Report to the Future Melbourne (Planning) Committee

**Ministerial Planning Referral: TPM-2013-29,
452-472 Elizabeth Street, Melbourne**

4 March 2014

PLANNING REPORT - MINISTERIAL REFERRAL

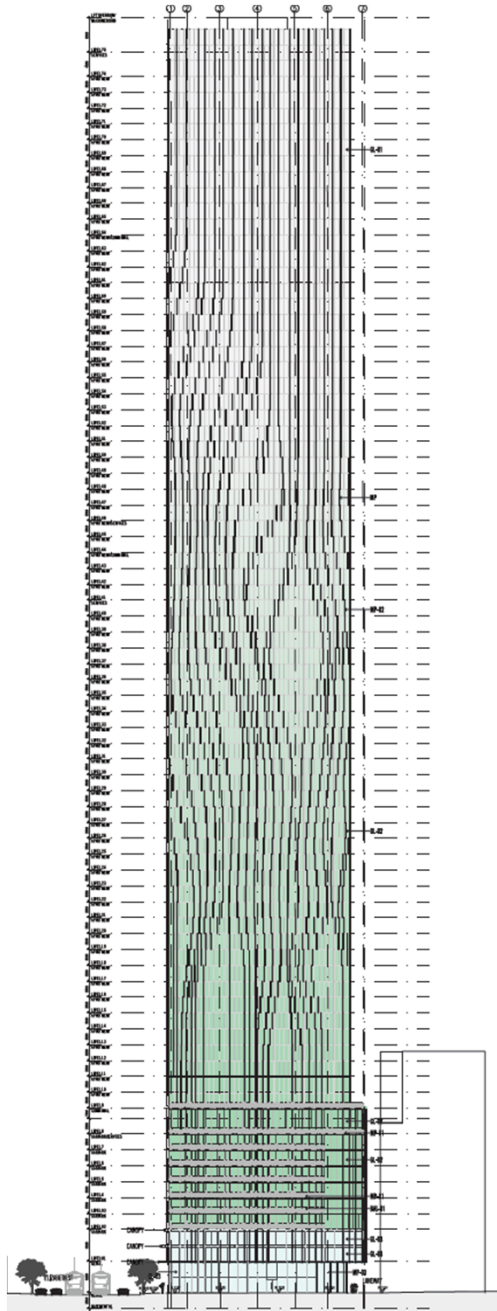
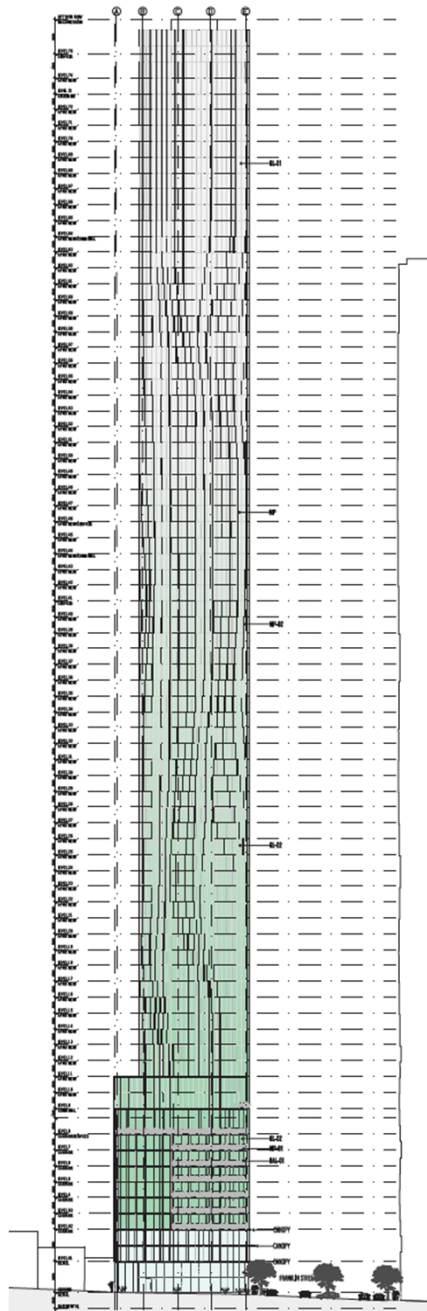
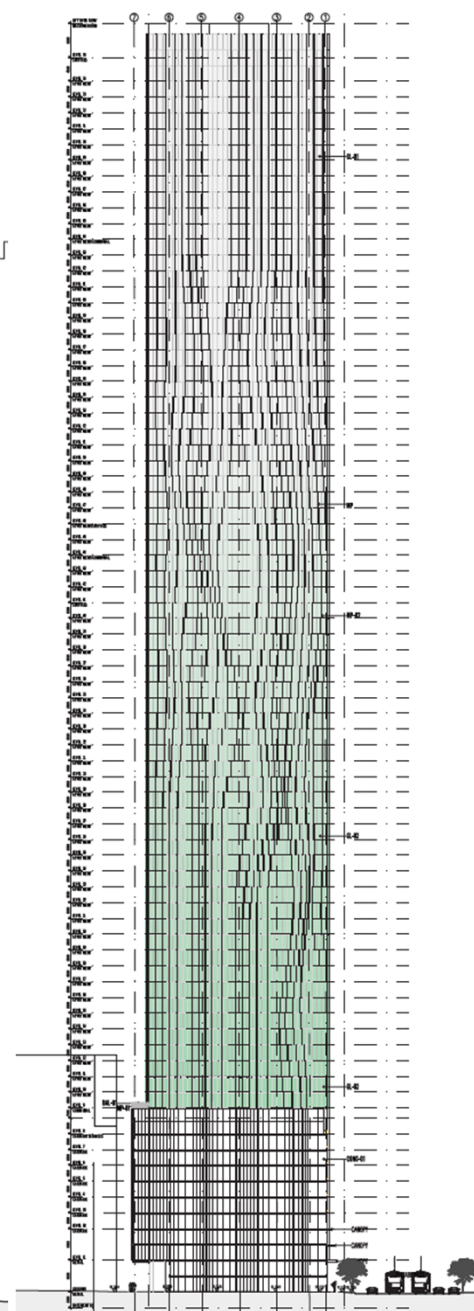
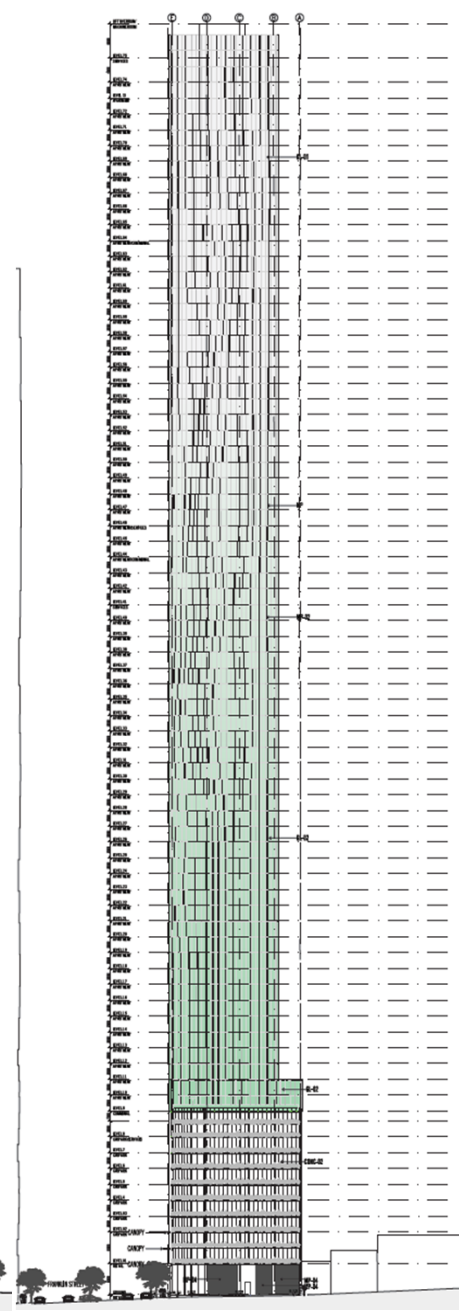
A substantial area of blank wall presents to the north, and the relationship of this wall with the east elevation should be better-resolved. We otherwise have no objections to the design or materials; however, significant redesign would be needed in response to the different built form recommended above.

BASEMENT 01

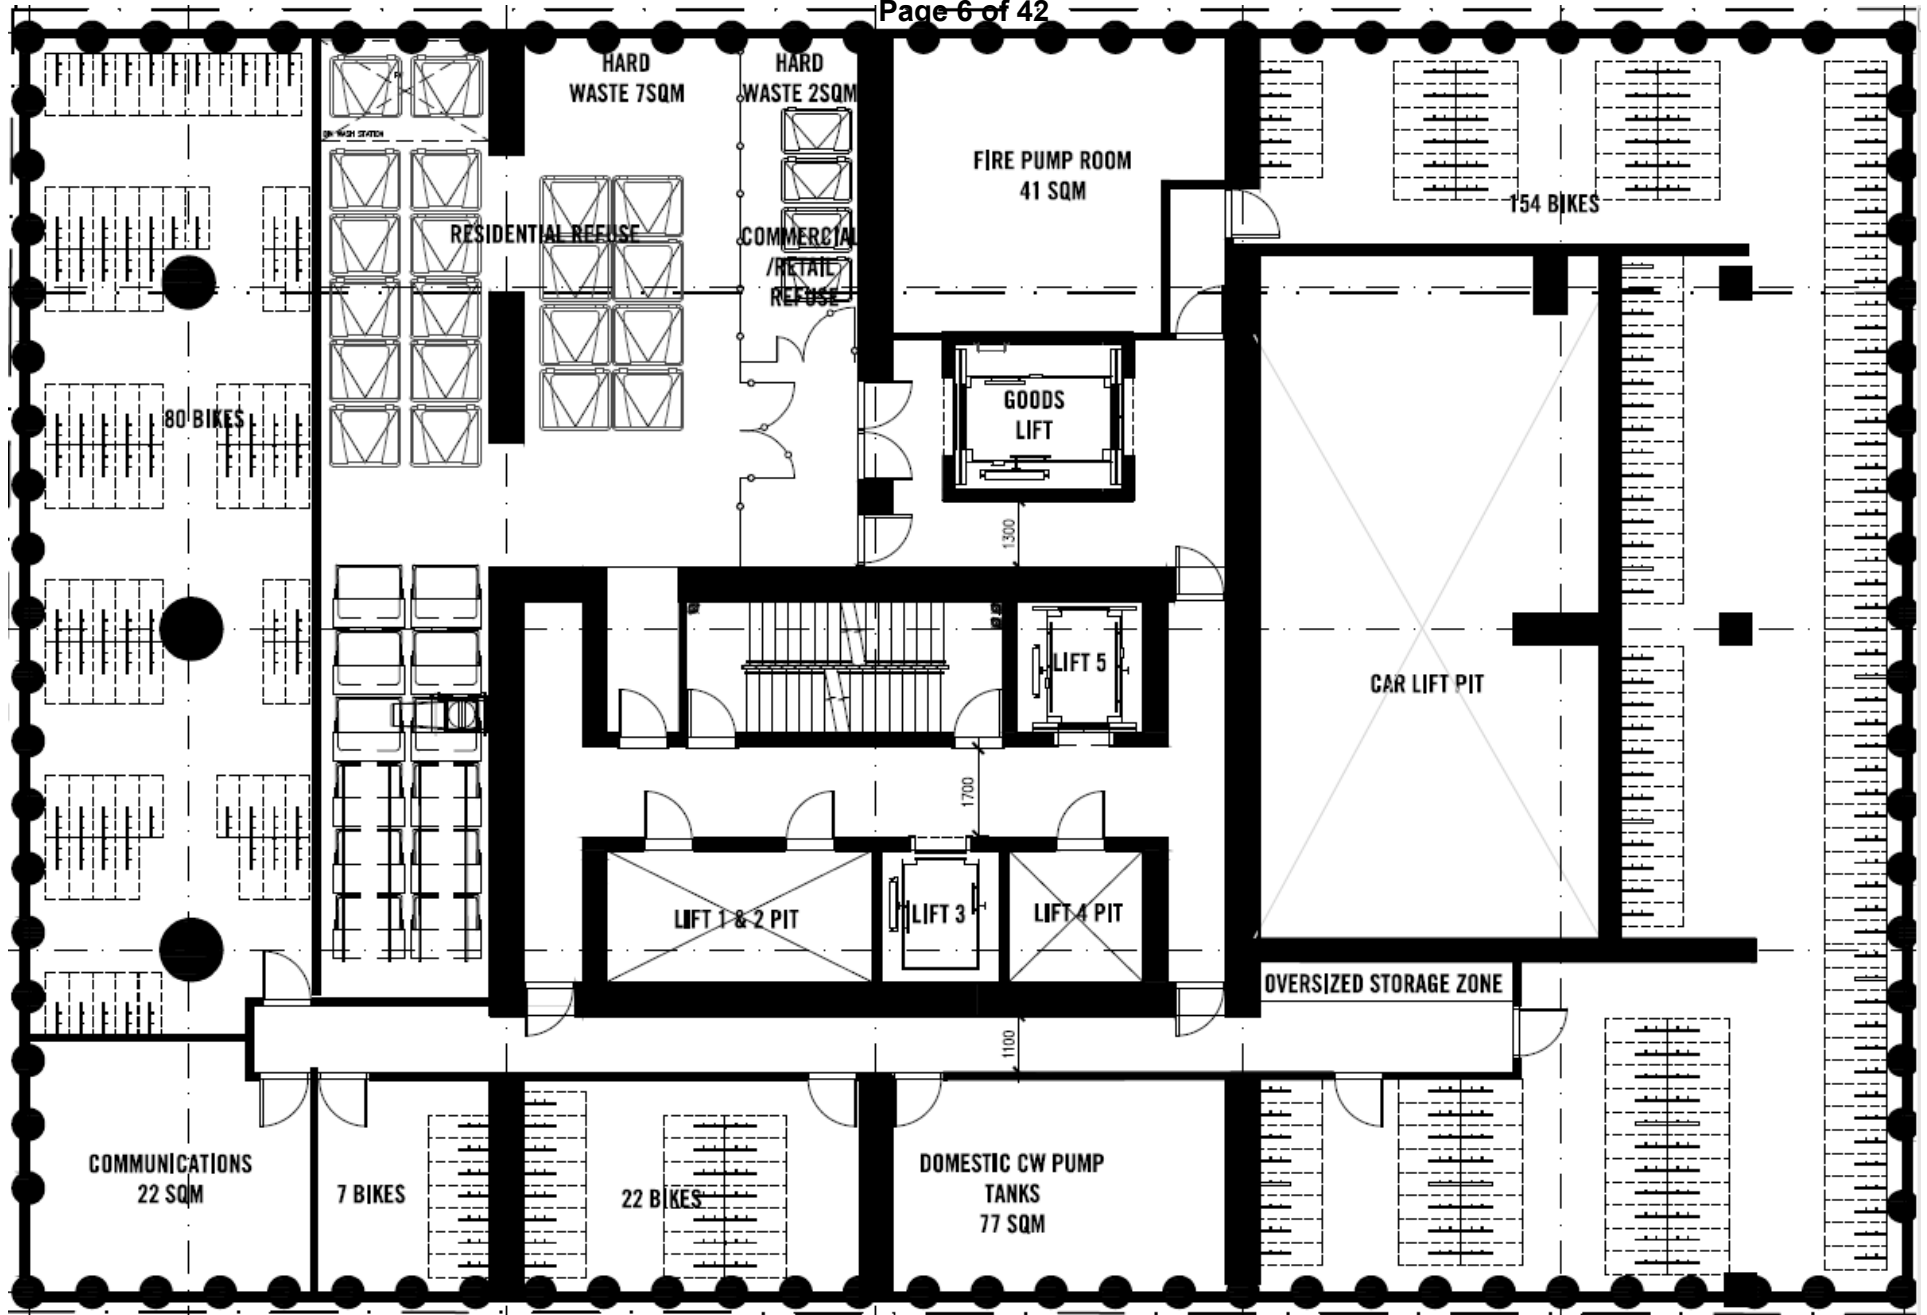
The Ratio Consultants report states "Residents and staff exiting the site will firstly call their vehicle via a systems operation panel located within the lift lobby area (opposite the concierge)." The report earlier mentions that all spaces are to be allocated to residents and the plans do not show a concierge station.

We have has serious reservations in relation to the proposed car queuing spaces. The "queuing" space consists of 3 completely independent car spaces which are liable to be opportunistically used by taxis and visitors.

There is no guarantee that the first entering vehicle will be the first to be serviced, which could lead to frustration. Consideration should be given to providing a single 3 vehicle queue rather than 3 individual queuing spaces. Entrance Cabin 1 is not readily accessible from the queue space closest to Franklin Street and it could be difficult to assess if it is occupied. It is not ideal for vehicles in the queuing spaces to have to reverse out into the lane. The queue space closest to Entrance Cabin 2 obstructs a pedestrian door.

It is proposed to widen the lane at ground level to "an overall effective laneway width of 6.2m." This additional width is used for car queuing. There will still not be sufficient room for two-way traffic if cars are queued. Adequate provision must be made for two-way traffic where the lane meets Franklin Street.

PLAN 01

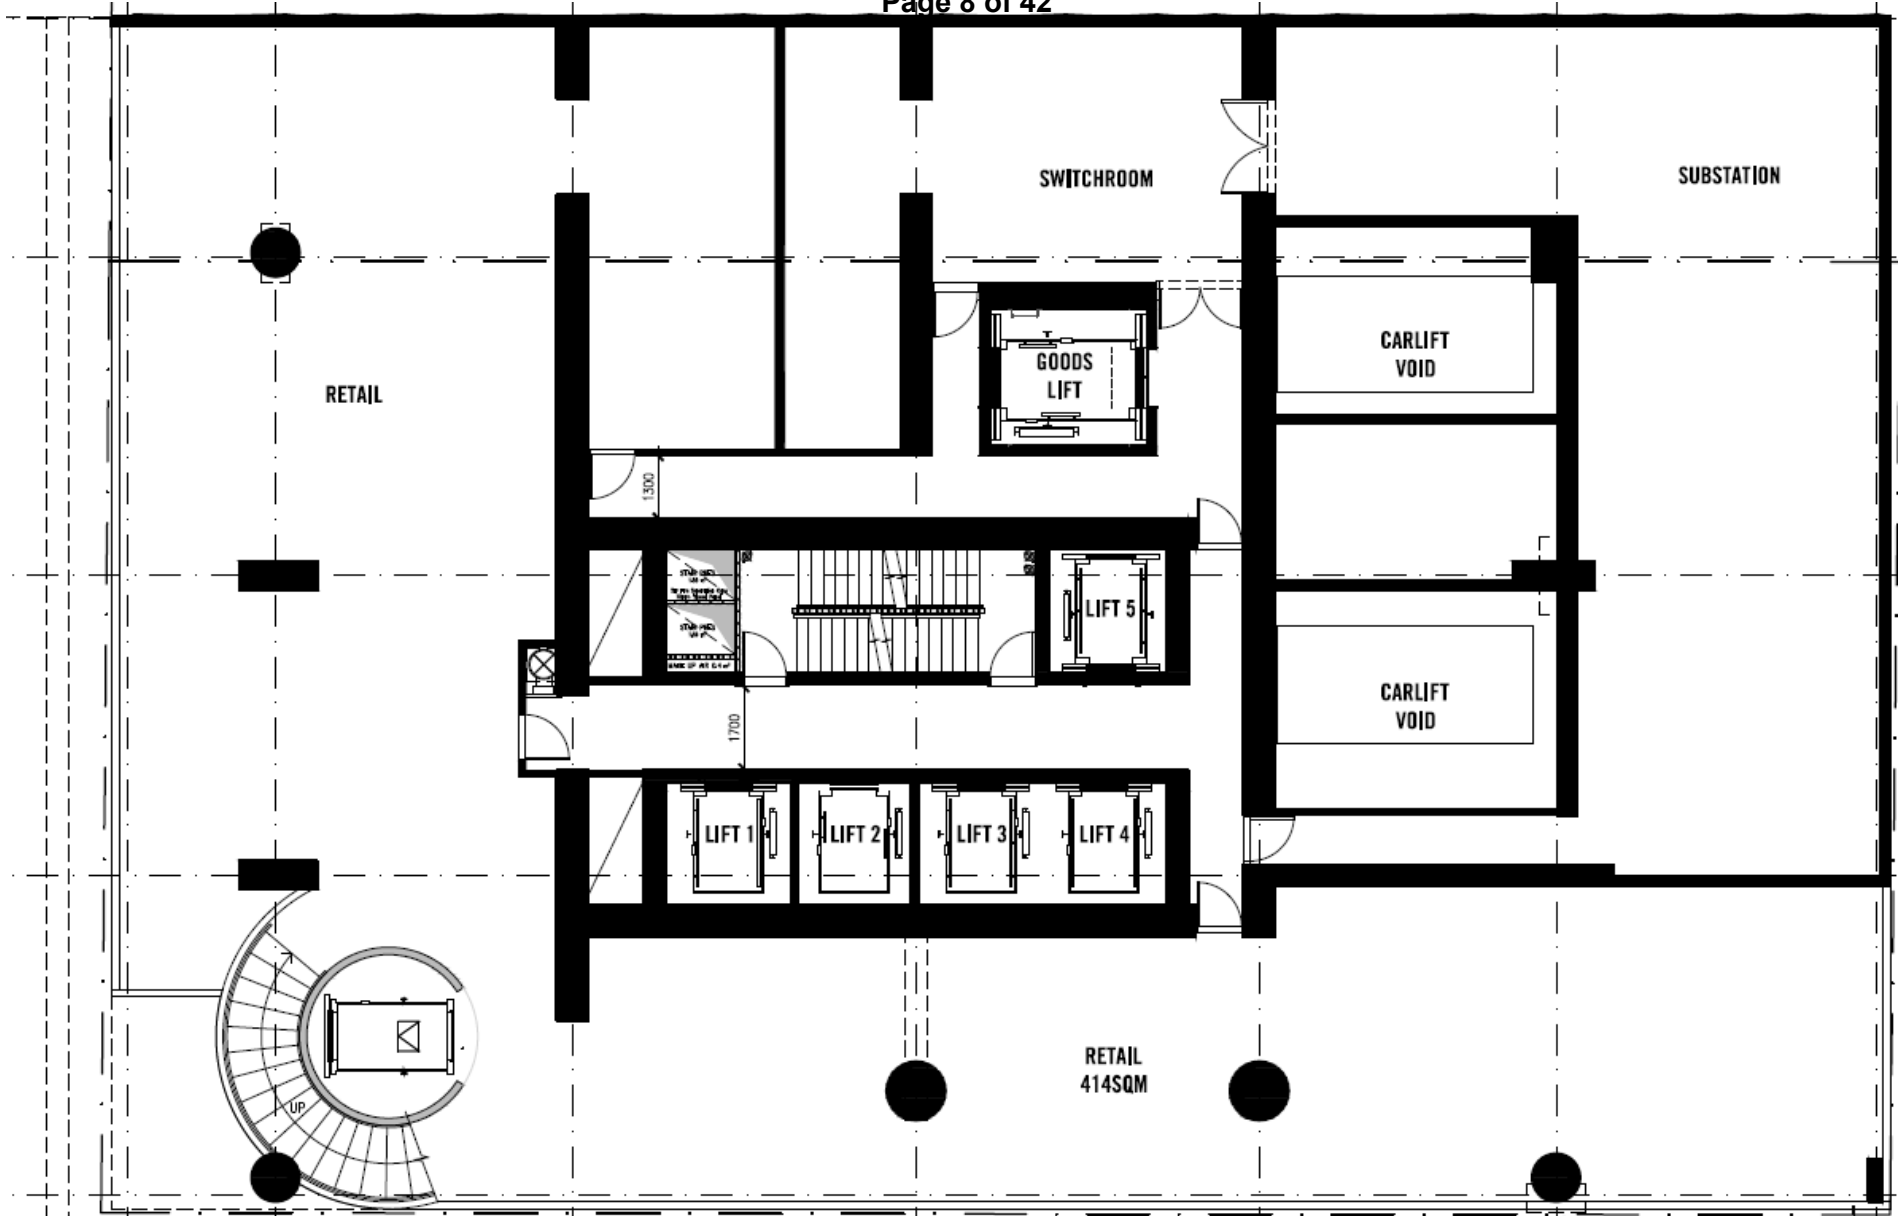
The architectural drawings do not show delineation between the structure of the proposed building and public realm. The floor levels of the building must not encroach onto any road adjoining the subject land.

It is noted that the existing building has a corner splay at the south-west corner of the subject land. The proposed ground floor drawing must be amended to show a 4.5 square metre splay at the corner of Elizabeth Street and Franklin Street.

A pedestrian sight triangle is required in the south-western corner of the site as well as a corner splay at the intersection of Elizabeth Street and Franklin Street.
